Origination Form
Proposed Revisions to a Standard Plans Index

| Originator: | Stepp, Richard | Index Number: | 102-110 |
| E-mail: | richard.stepp@dot.state.fl.us | Index Title: | Type K Temporary Concrete Barrier System |

To accommodate newer Standard Plans options, "Single-Slope" traffic railing and concrete barrier shapes are being added as permanent barrier connection options throughout Index 102-110. Also, per a revision request from the State Materials Office, the word "fabric" is being removed from "geotextile" callouts.

THRIE-BEAM GUARDRAIL POSITIONING DETAIL

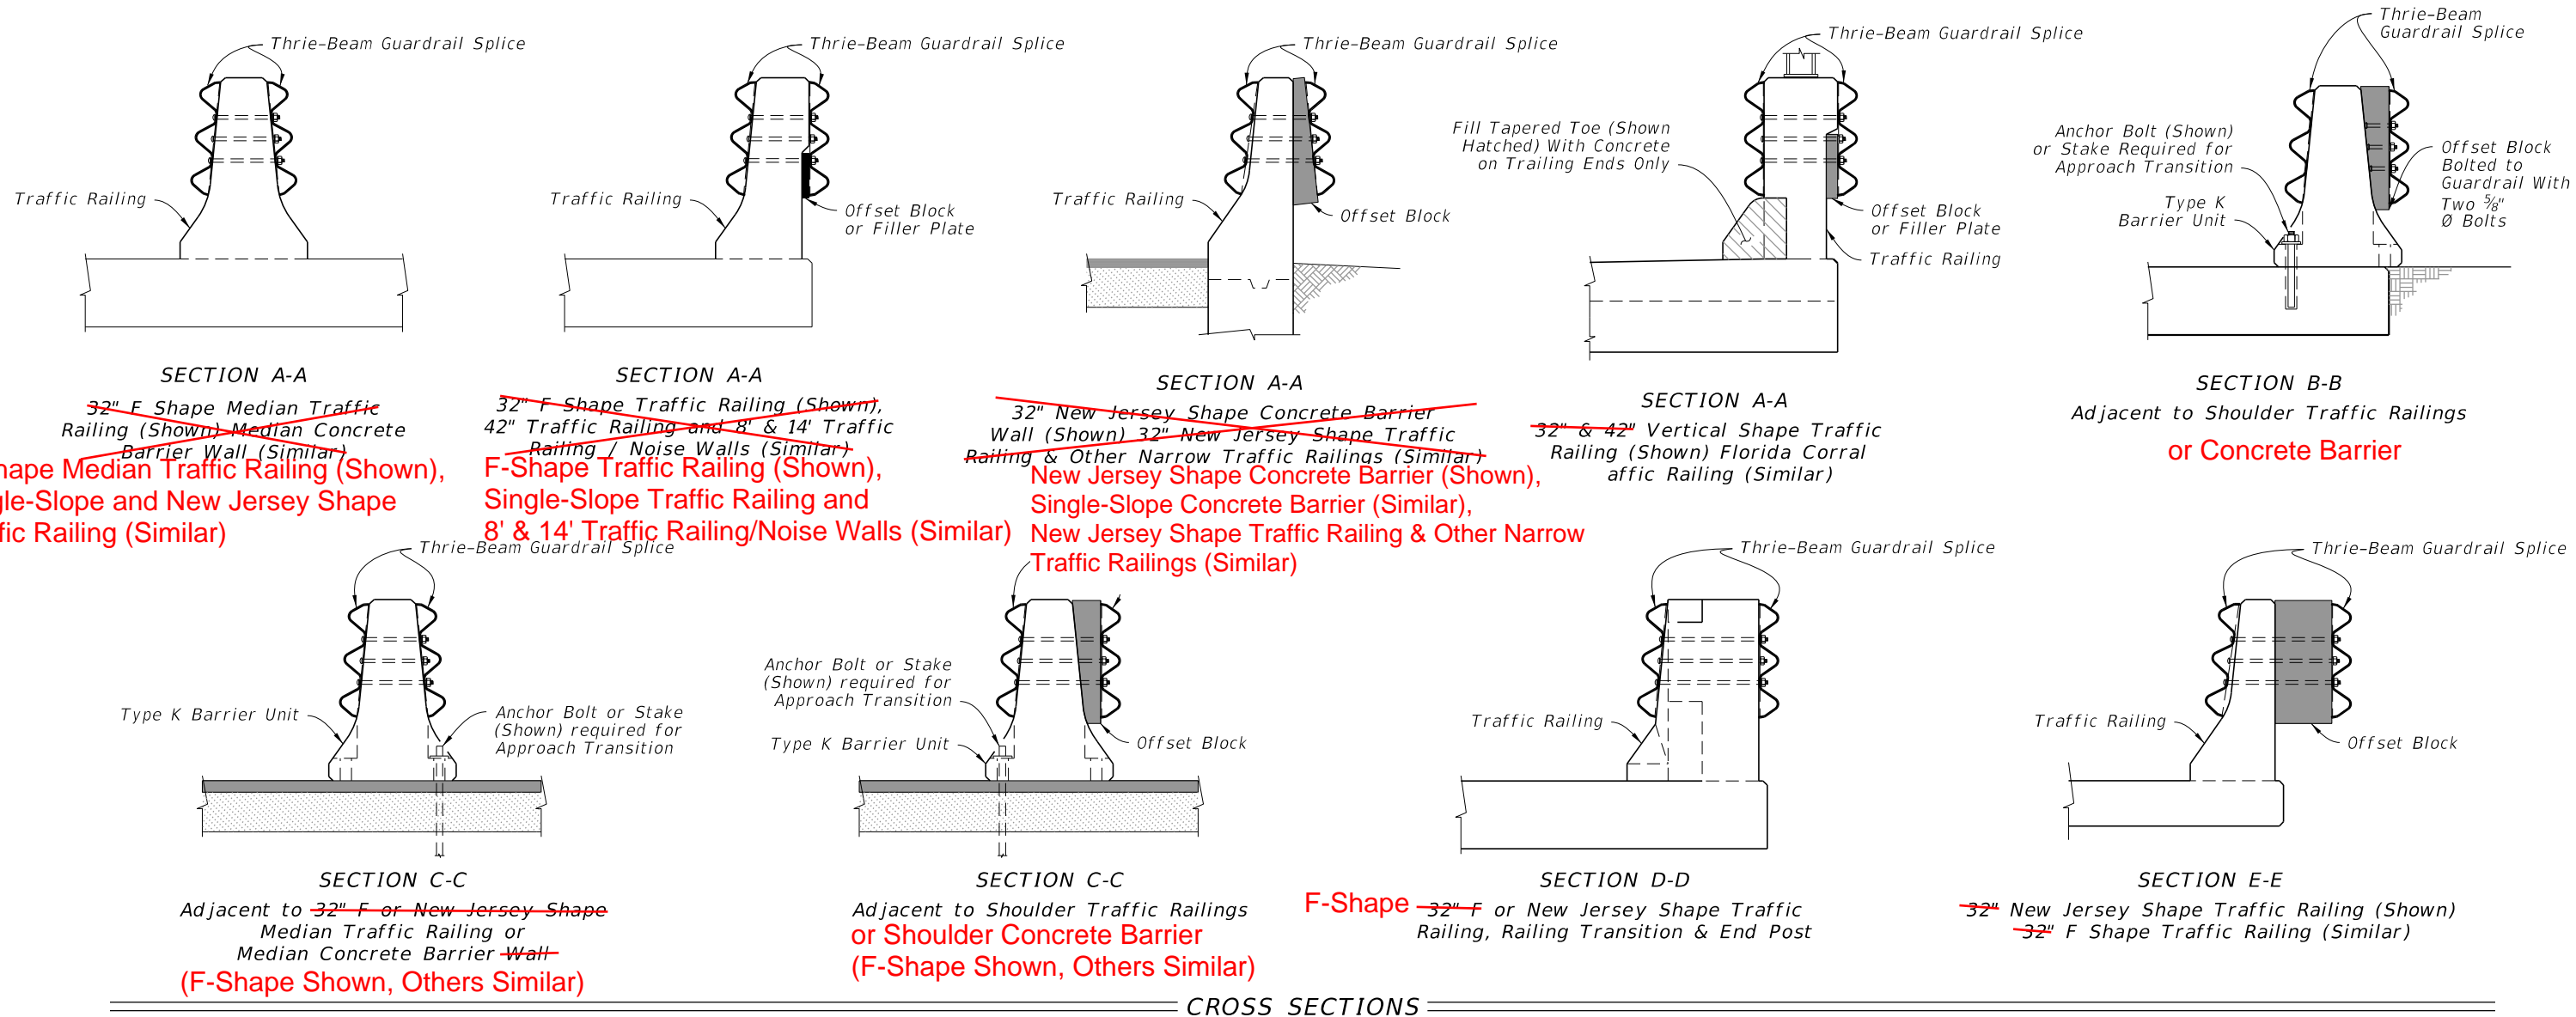
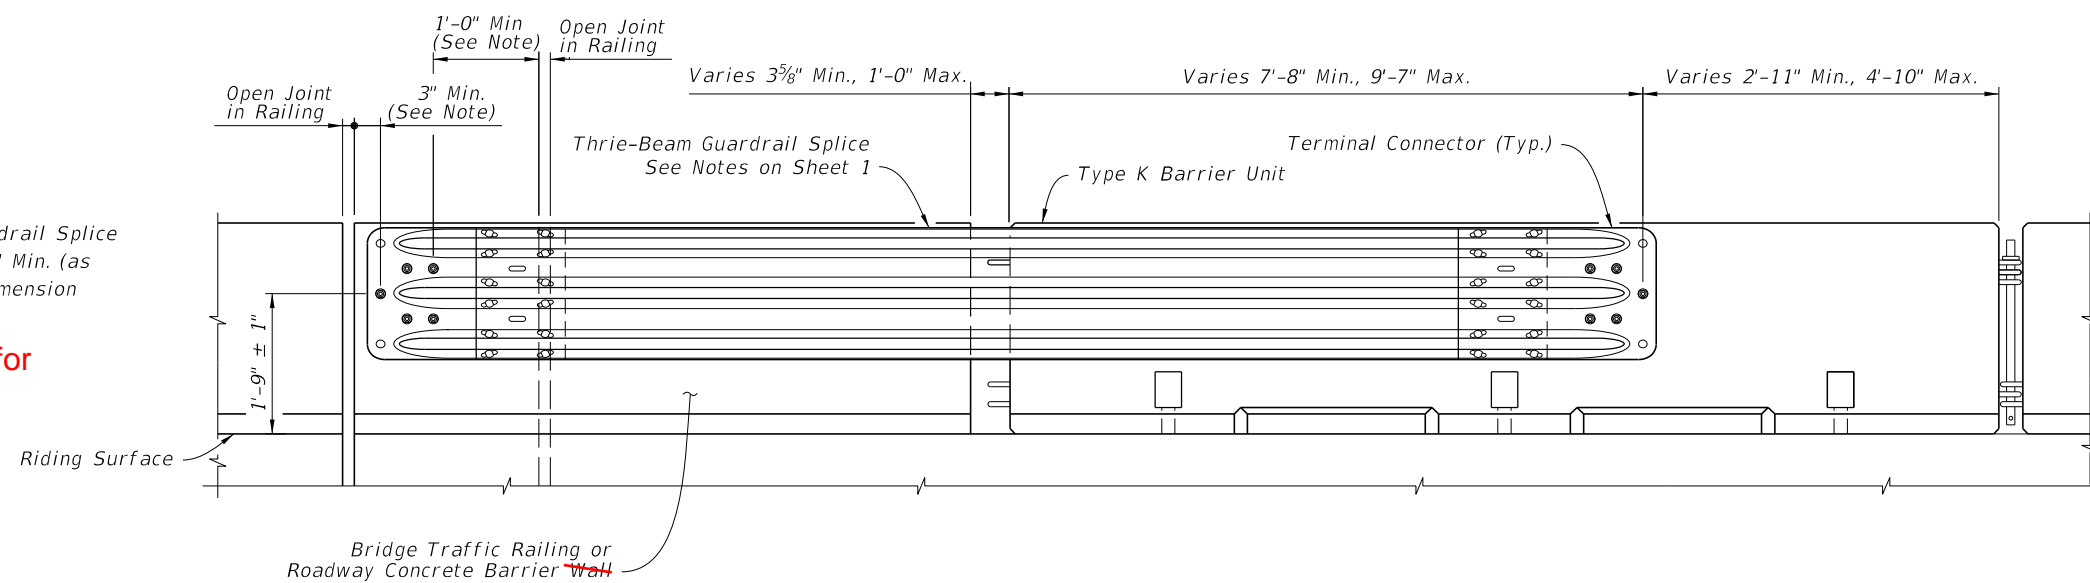
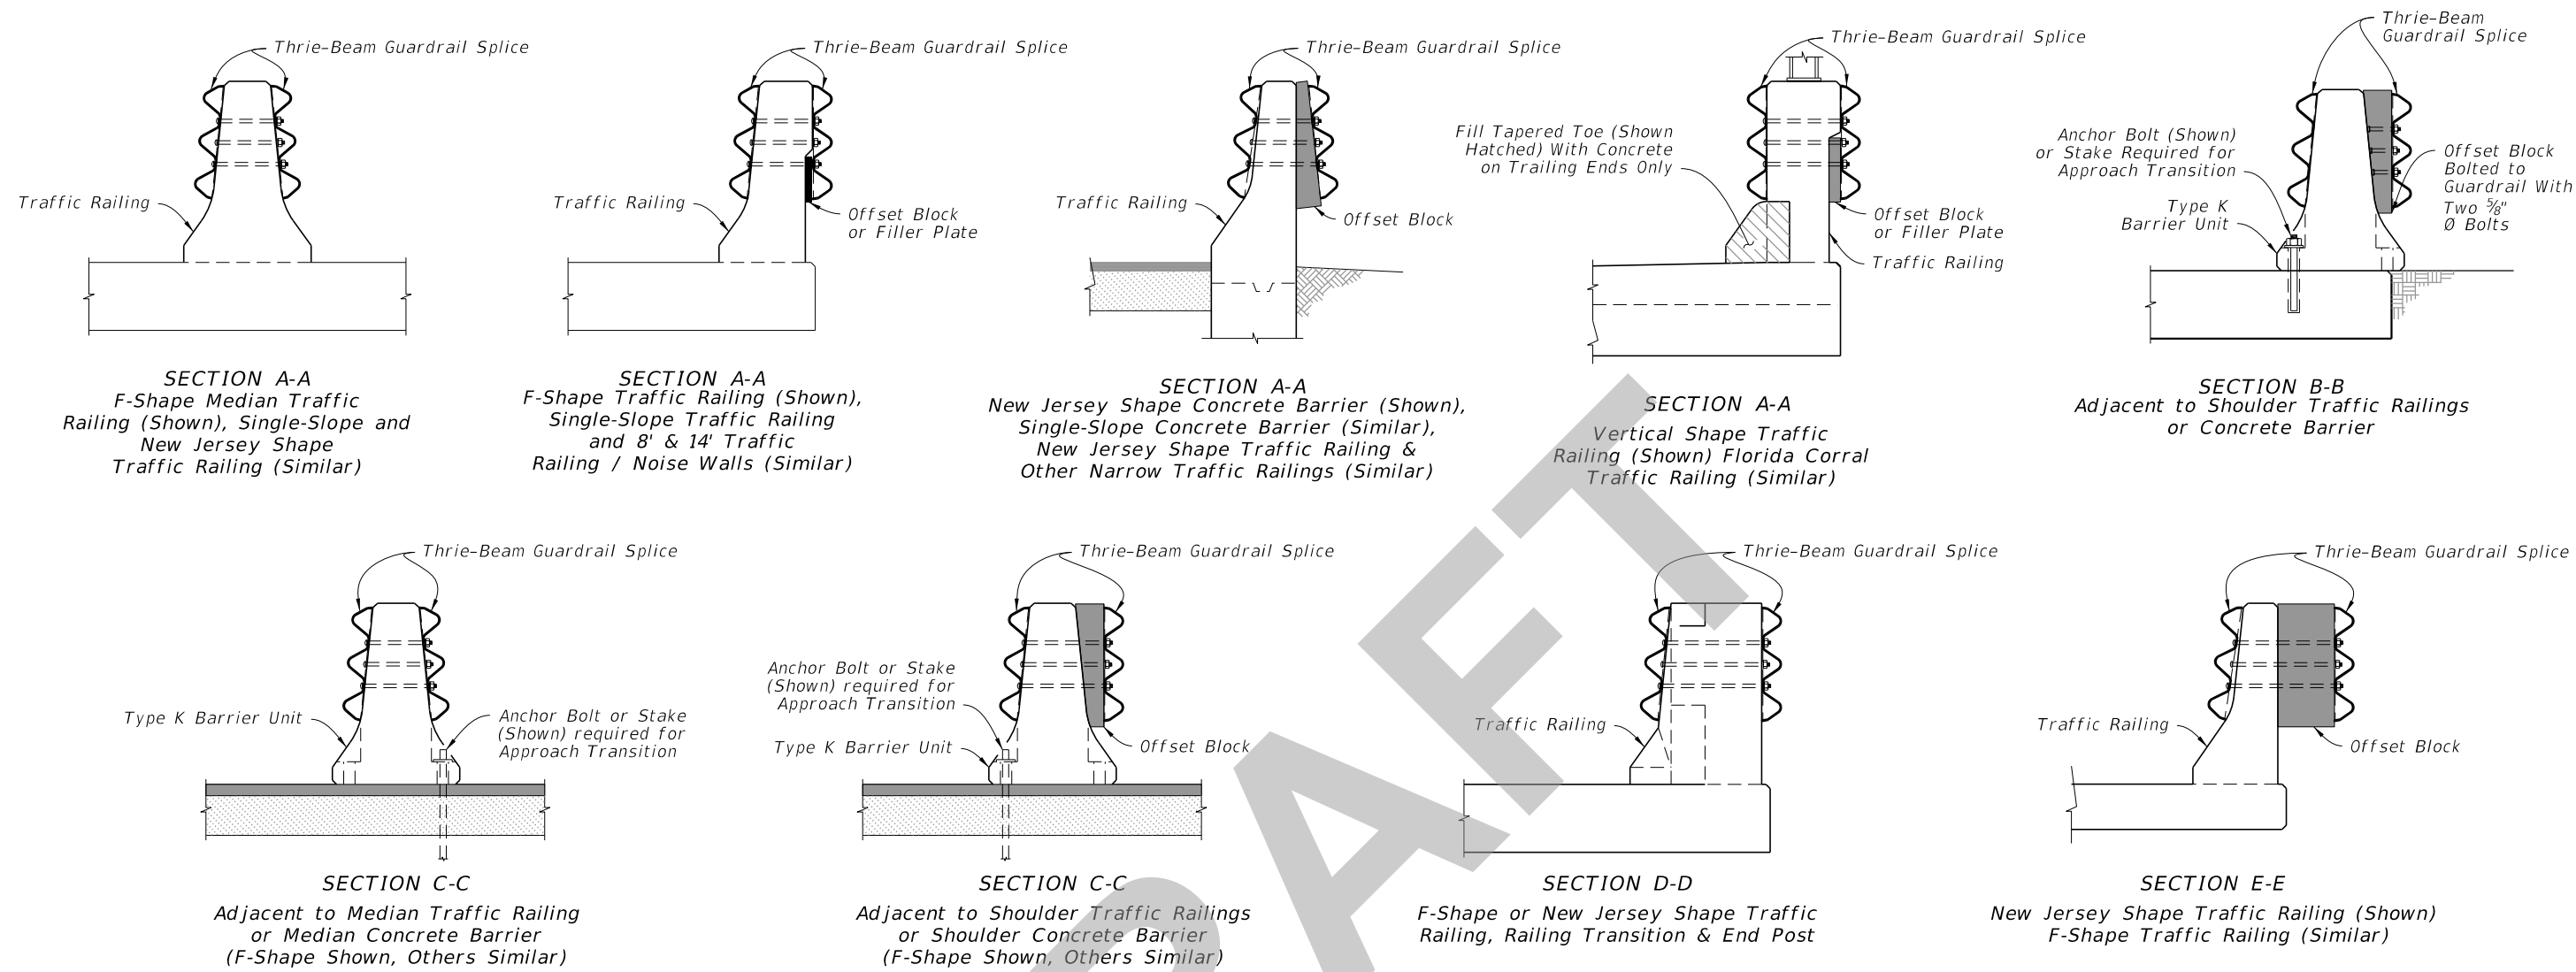
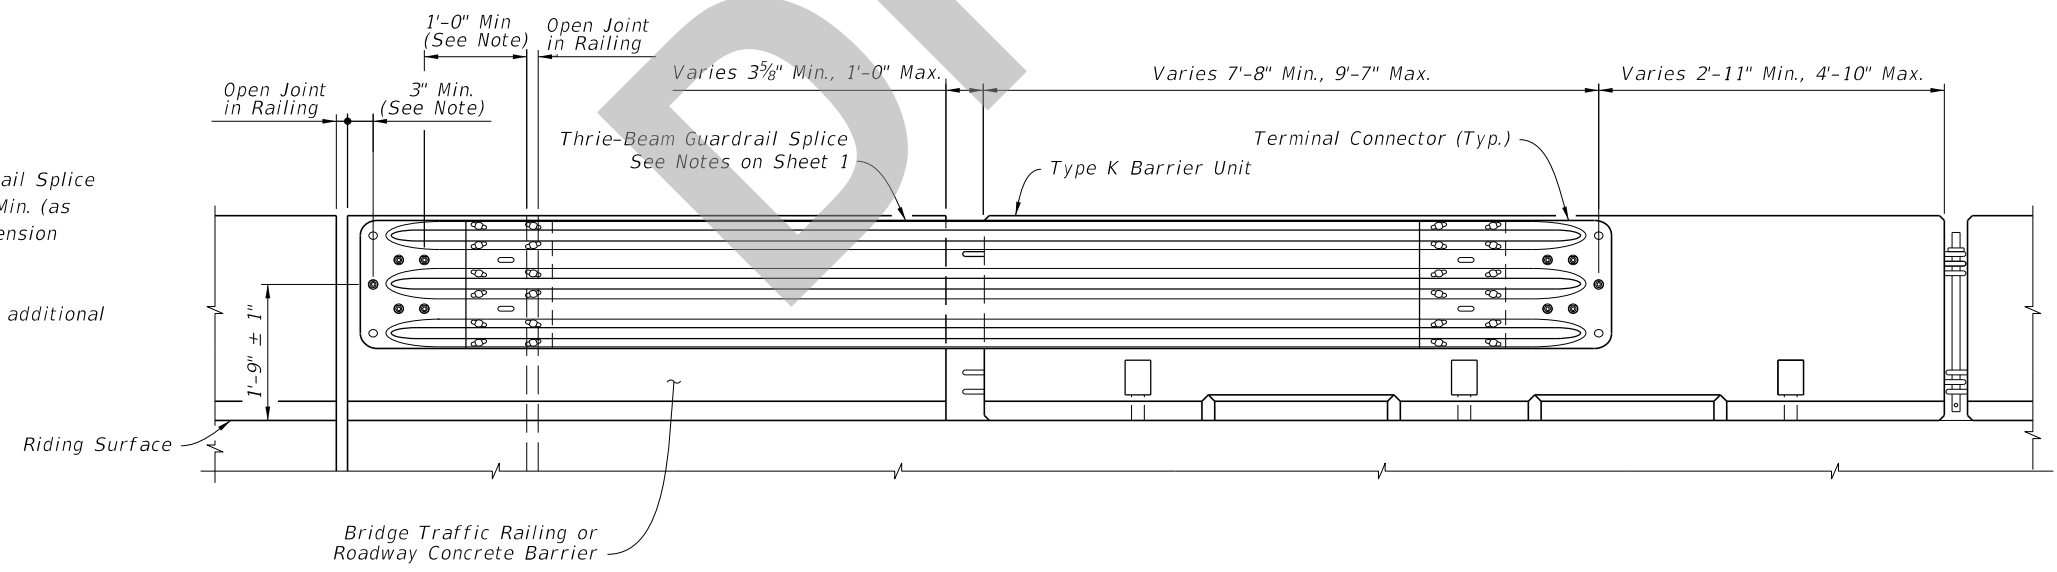
Sheets 7-10: Revised detail labels to simplify and include "Single-Slope" Traffic Railings and Concrete Barriers where applicable

- Shift Thrie-Beam Guardrail Splice beyond Open Joint 1'-0" Min. (as shown) when 3" Min. dimension can not be obtained
- See Sheets 7-9 for additional details

1. Shift Thrie-Beam Guardrail Splice beyond Open Joint 1'-0" Min. (as shown) when 3" Min. dimension can not be obtained
2. See Sheets 7 thru 9 for additional details
